RECORD COPY of ASI-023, included as
6 of 6 ASIs for reference with SPA-03

PROJECT NAME:	One River Run (Kindred) 75 Hunki Dori Ct. Keystone, CO 80435	ASI #:	023	<input checked="" type="checkbox"/> OWNER <input checked="" type="checkbox"/> ARCHITECT <input type="checkbox"/> CONSULTANT <input checked="" type="checkbox"/> CONTRACTOR <input type="checkbox"/> FIELD
PROJECT #:	117033	DATE OF ISSUANCE:	05/28/2024	
OWNER:	One River Run Acquisition Keystone Investments, LLC 132 West Main Street, Suite D Aspen, CO 81611	ARCHITECT:	OZ Architecture, Inc.	
		TO CONTRACTOR:	PCL Construction Services, Inc	
		CONTRACT FOR:	GMP/Building Permit Resubmittal	
		CONTRACT DATED:	September 23, 2021

DESCRIPTION: This ASI provides an updated Civil drawing to confirm removal of an existing light pole in the vicinity of the detention basin serving the adjacent Red Hawk property in the SE corner of the project. This issue was initially addressed by the Design Team in response to RFI-01226 on 4/26/2024.

Light Pole Relocation

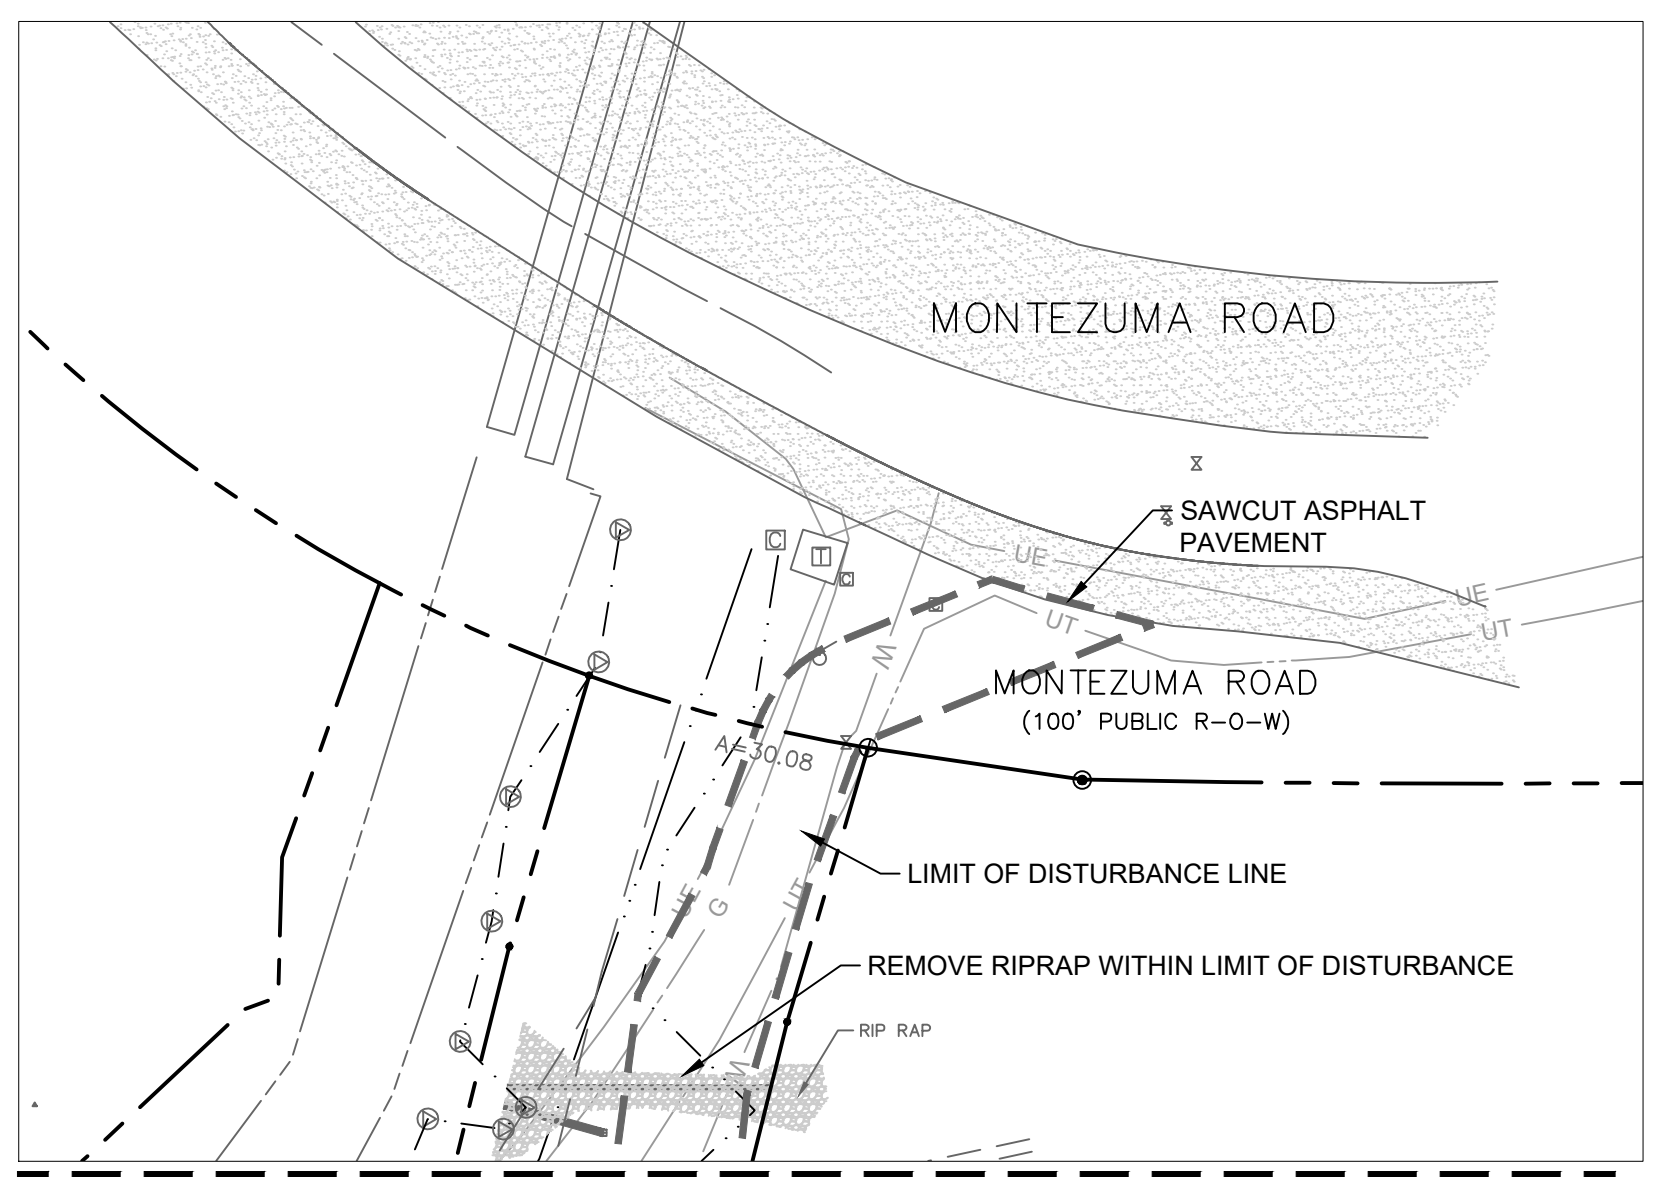
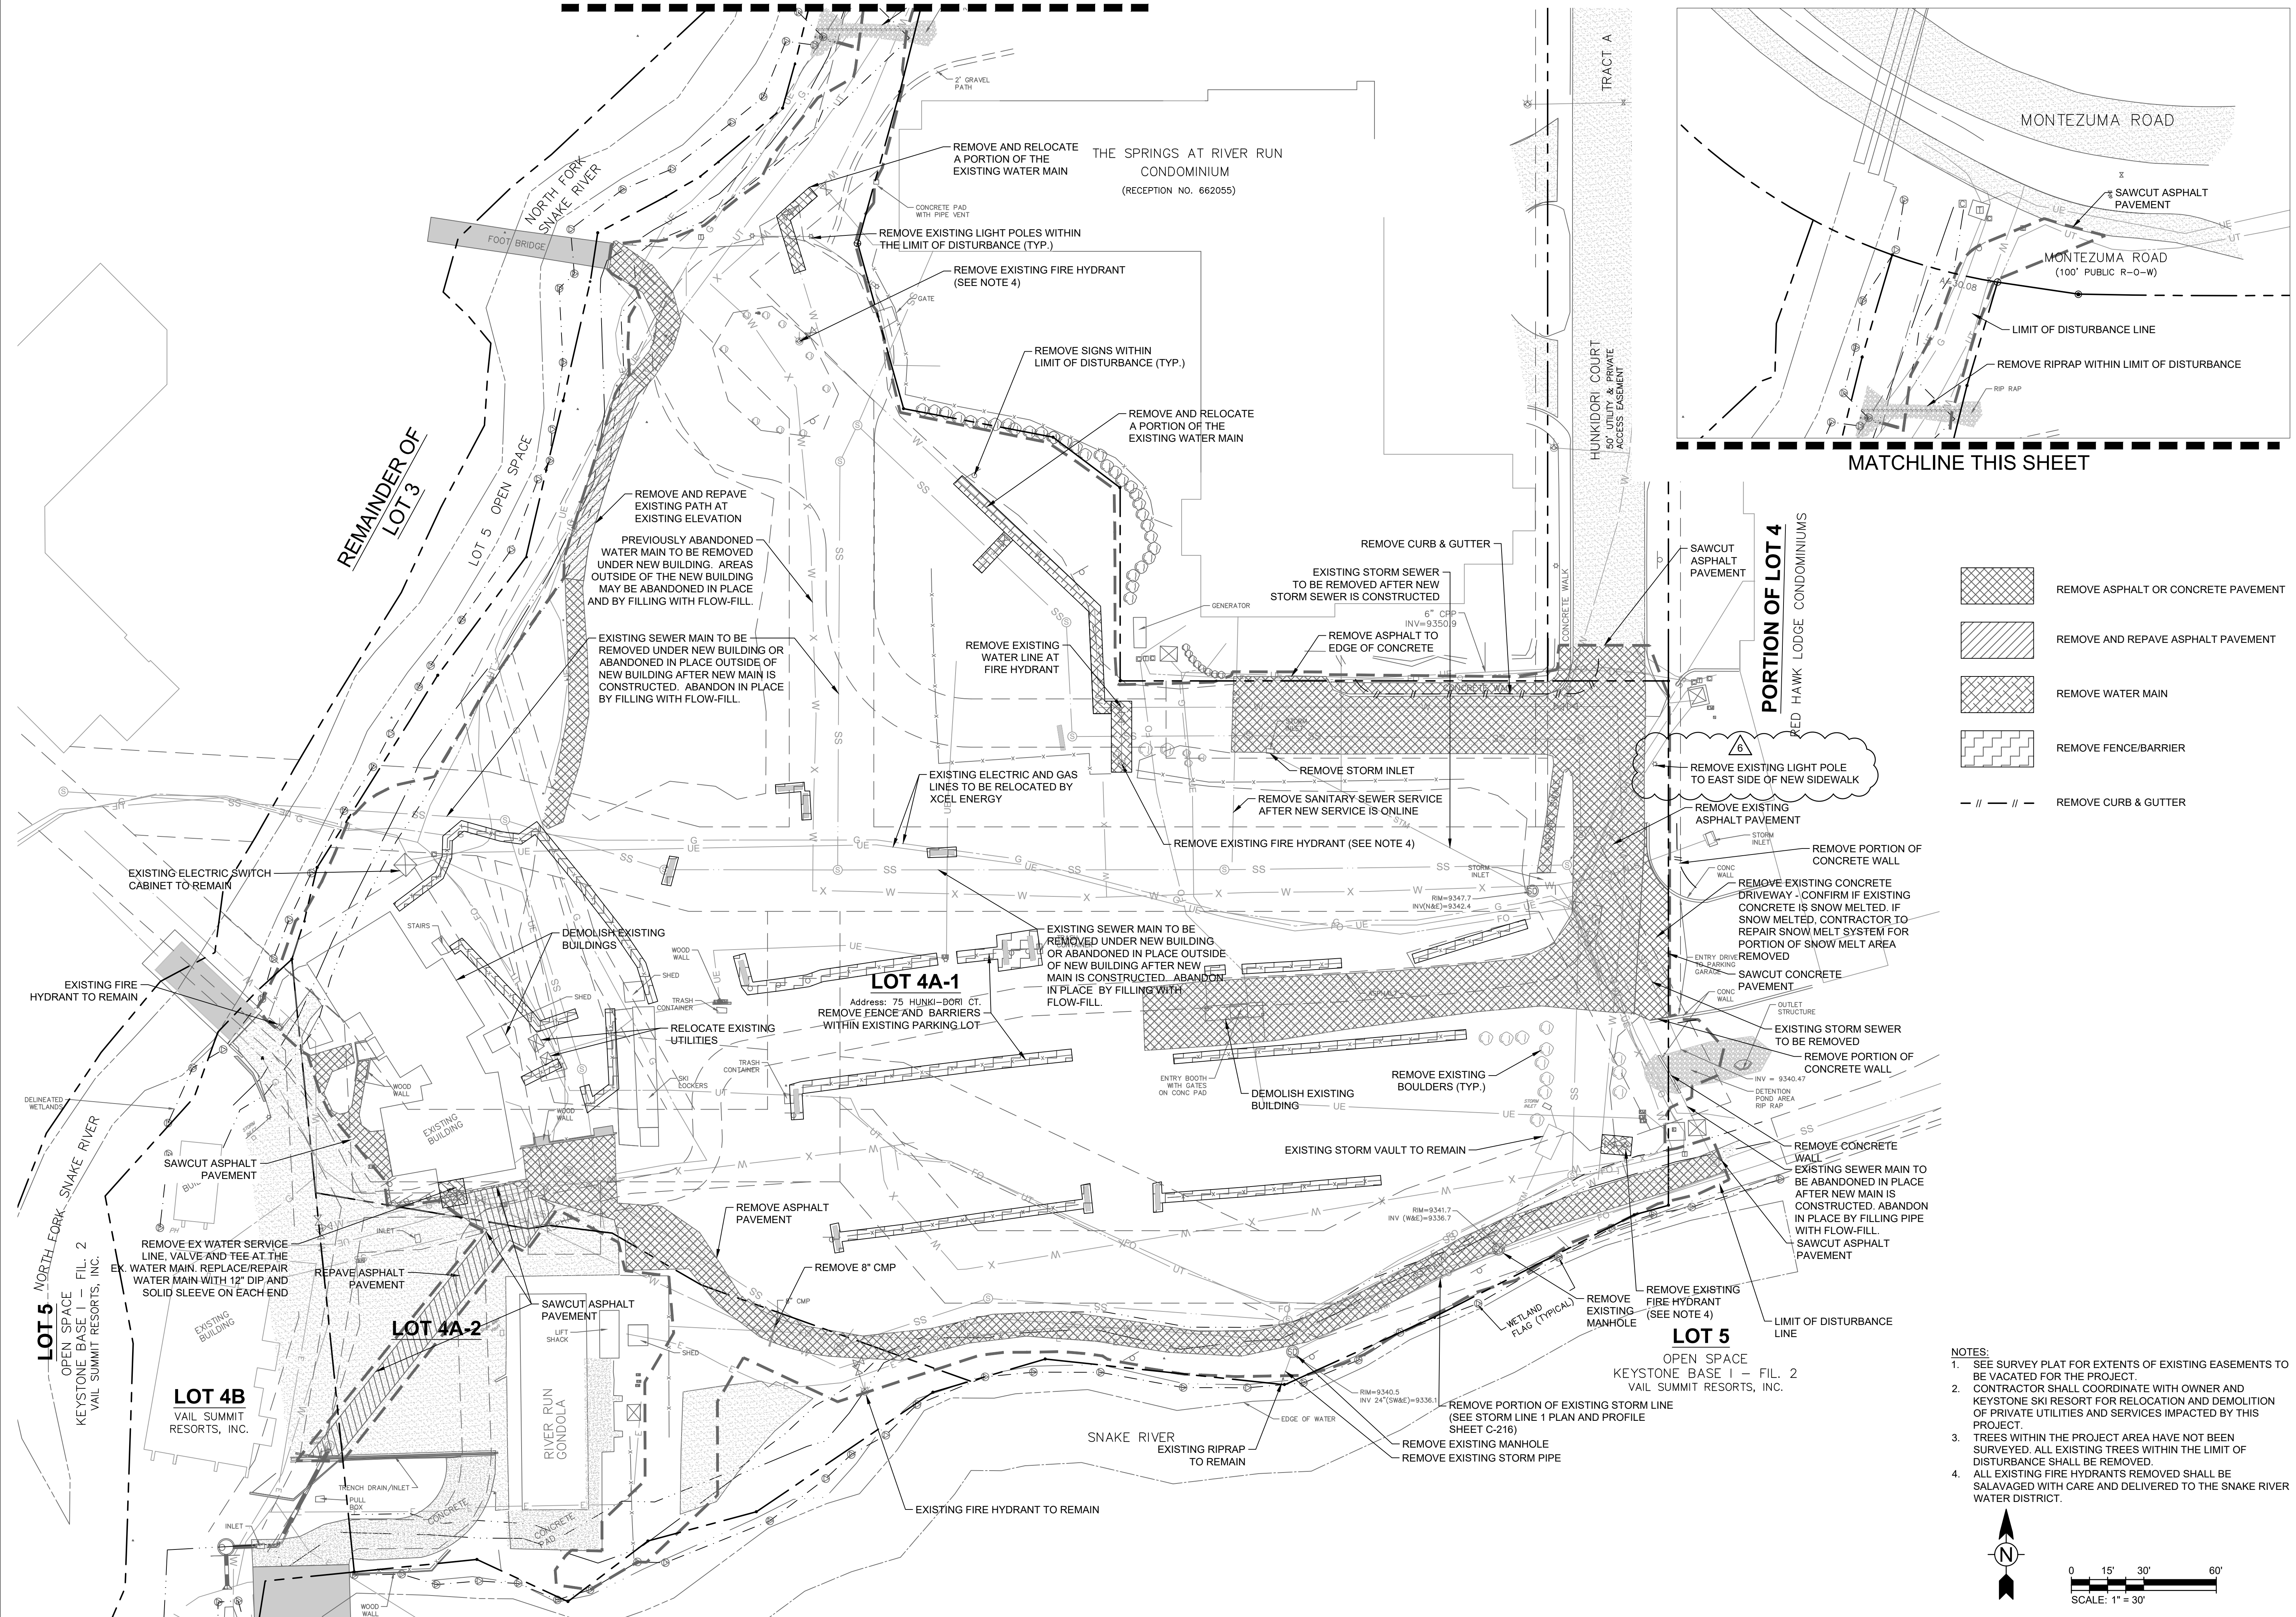
[Submitted: 4/16/2024 by Ryan M Bell, PCL Construction Services, Inc. Rev #0]
 Per RFI-132. the existing light pole on the East side of the property was noted as being relocated 5' East from its current location. At this time, PCL has begun staking and surveying the area to prep for site hardscapes and it was established that if the pole is to relocate 5' East that it would be installed within the boulder wall and right on the project's property line. Due to this issue, PCL proposes to either relocate the light pole roughly 8' North and 5' East from its current position or if acceptable, remove the light pole entirely.
 Please advise if it is acceptable to relocate the light pole 8' North and 5' East or remove the light pole in its entirety.
Reason: Location Conflict
Cost Impact: Additional conduit and cable to relocate light pole further away from intended conflict location.

Lighting consultant has noted existing light poles is outside their scope and not included in the photometric calculations. OZ recommends to remove light in its entirety.

C-102

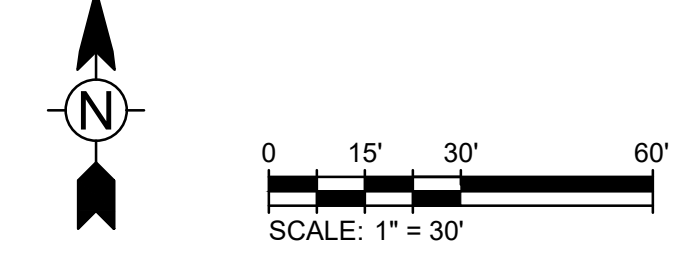
One (1) full size, revised Civil Sheet; C-102.

1 PARKING GARAGE SITE PHOTOMETRIC PLAN - OVERALL
1/16" = 1'-0"

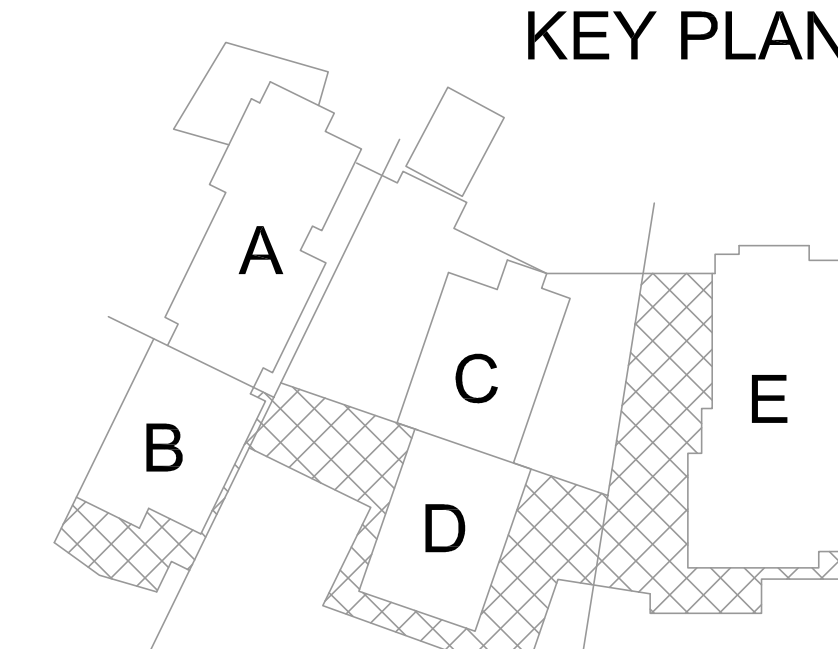
During processing of the RFI, the Lighting Consultant noted that the pole light in question was not included in the approved photometric calculations. This is supported by Sheet LT-001 (Overall Site Photometric Plan) which is attached for reference. Discussions with both the newly formed Town of Keystone Community Development Department and the KNC indicated support for its removal, so long as the adjacent sidewalk is fully snow melted. OZ can confirm that to be the case per the approved Site Plan on file. Further support for removal, rather than relocation of the light pole in question is based on the fact that it is not shown on the approved Photometric Plan. This is because, as noted by the Lighting Designer in the RFI response, it was not included in the photometric calculations which are the basis of previous AHJ approvals, thus compliant site lighting is provided for the entire project without it.

One (1) full size Lighting Plan (previously approved) provided for reference only; LT-001.
